Origination Form

Proposed Revisions to a Standard Plans Index

Originator:	Stepp, Richard	Index Number:	536-002
Date:	7/25/2024	Sheet Number(s):	1, 27, 28
E-mail:	richard.stepp@dot.state.fl.us	Index Title:	Guardrail Transitions and Connections for Existing Bridges

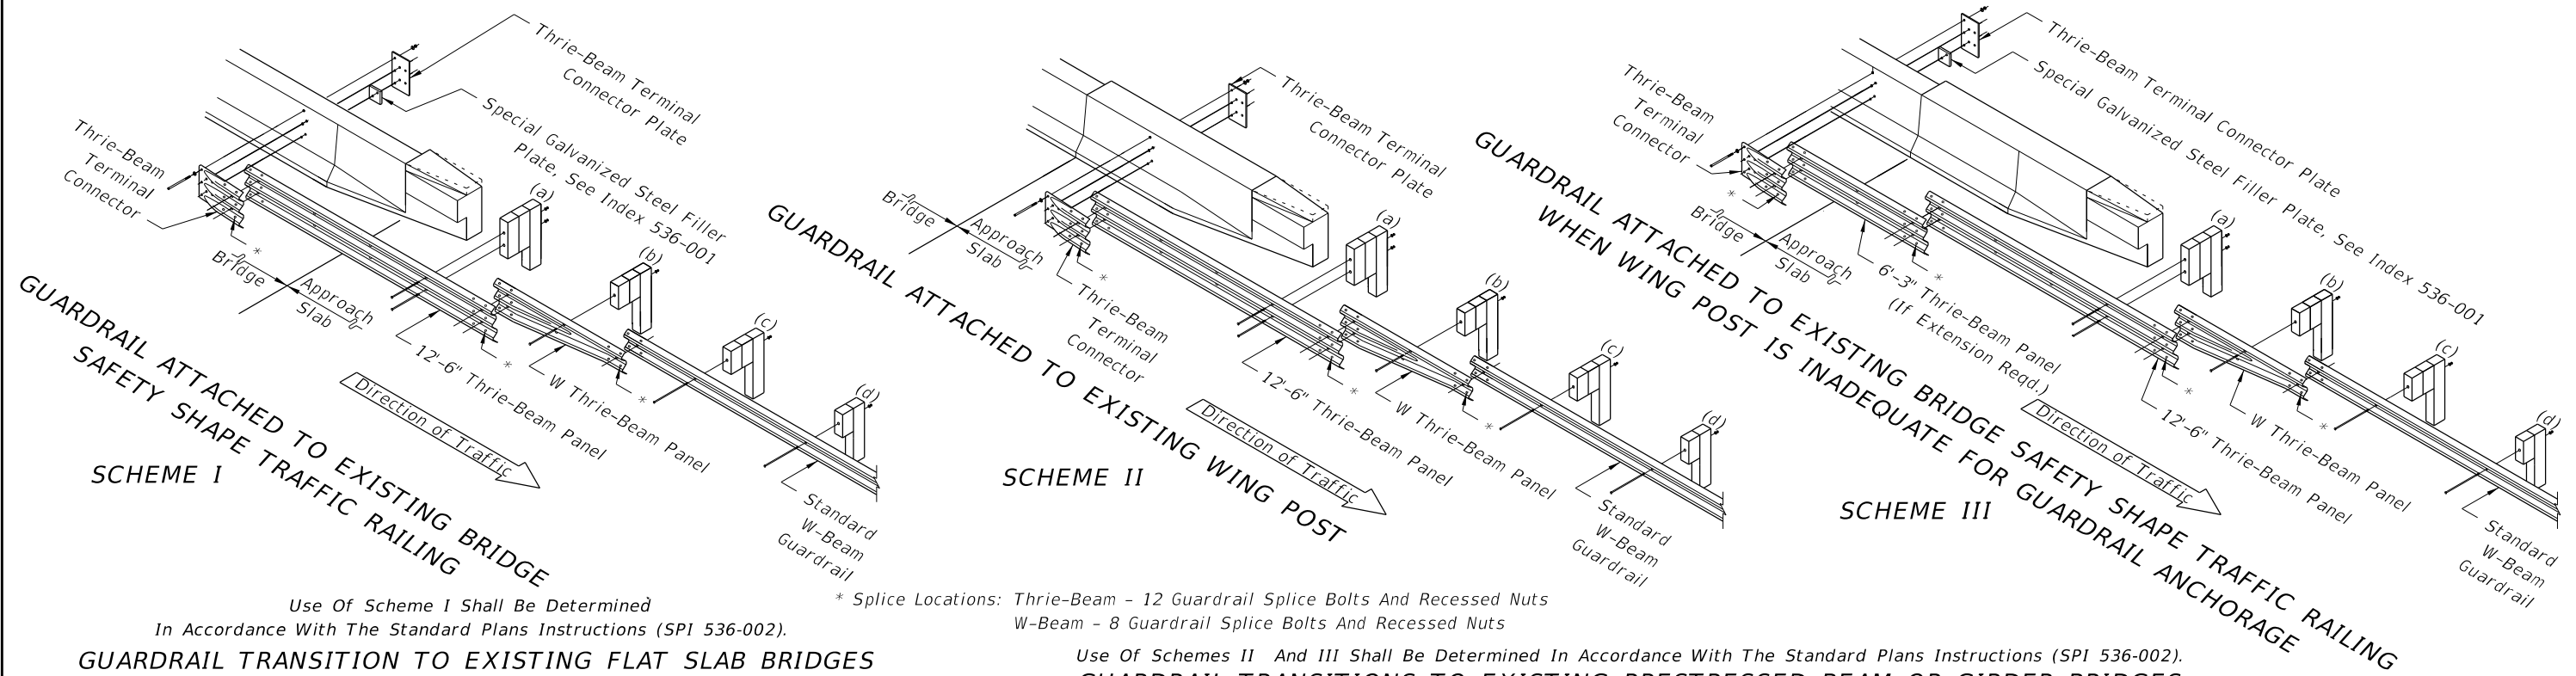
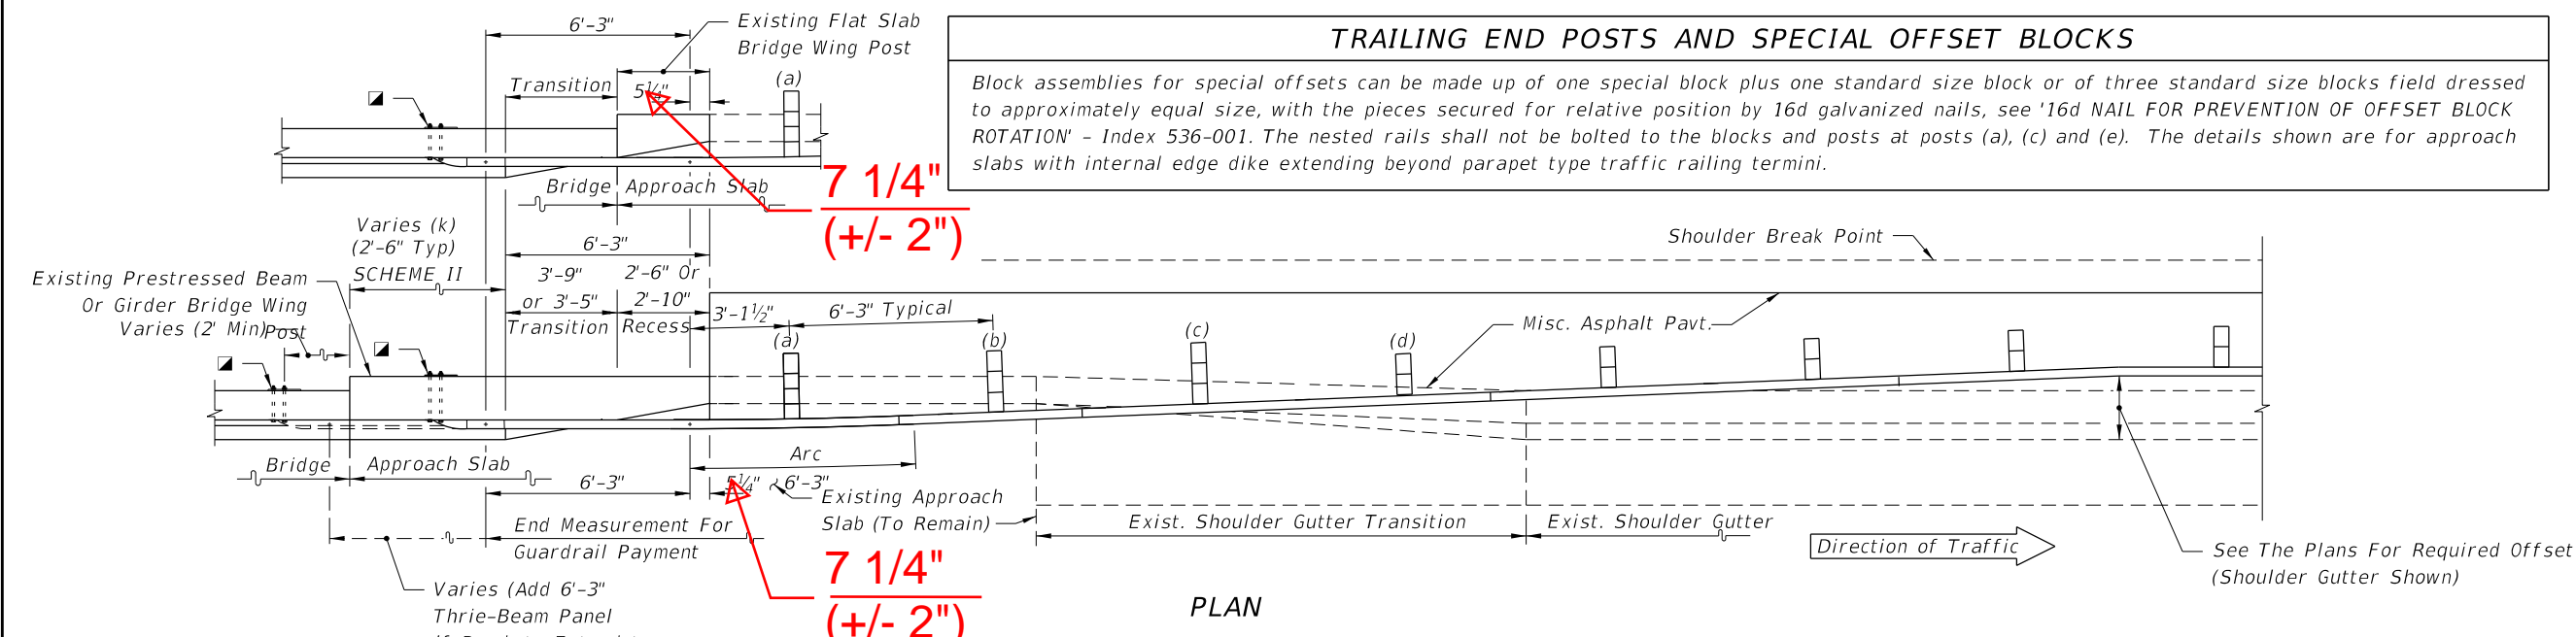
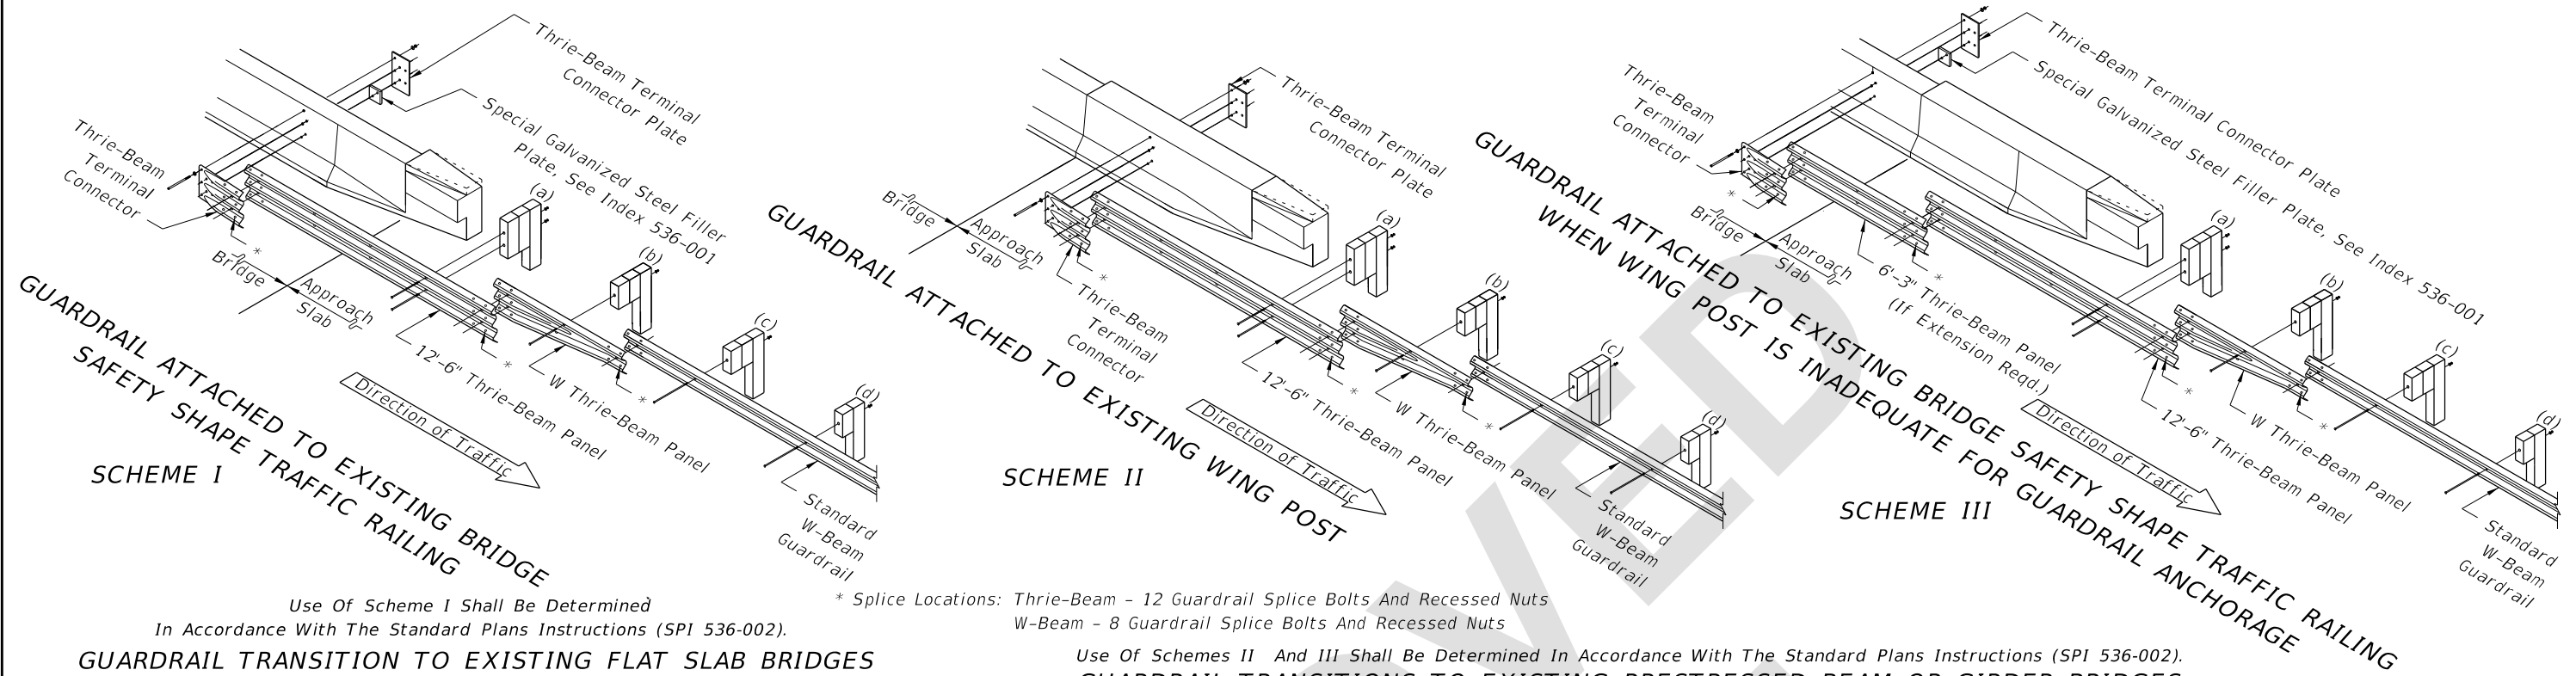
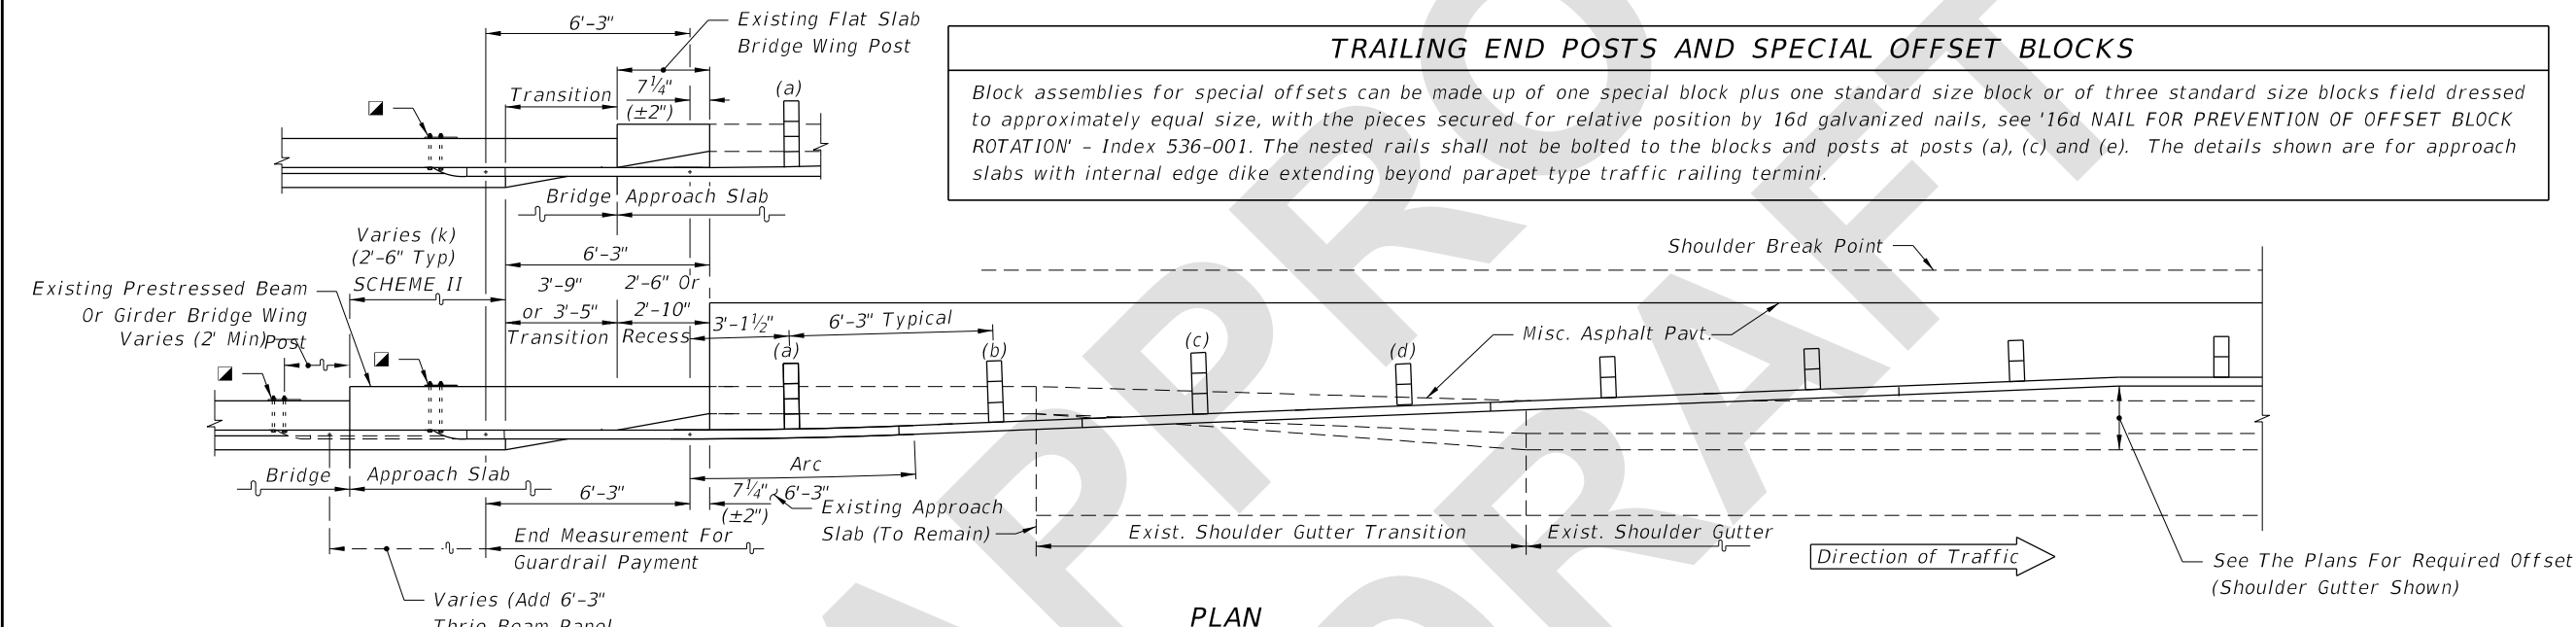
Sheet 1: Added a note explaining required rectangular washer usage to General Note 2.
 Sheet 27: Changed guardrail's longitudinal alignment measurement from the end of concrete from 5 1/4" to 7 1/4" (+/- 2")
 Sheet 28: Changed guardrail's longitudinal alignment measurement from the end of concrete from 5 1/4" to 7 1/4" (+/- 2")

Sheet 1: Contractors questioned if the rectangular washer policy of the referenced Index 536-001 applies, so this added note provides that clarification.
 Sheets 27 & 28: Changed longitudinal dimension to align with crash-tested systems and provide a broader tolerance for placement that follows successful practices in other states.
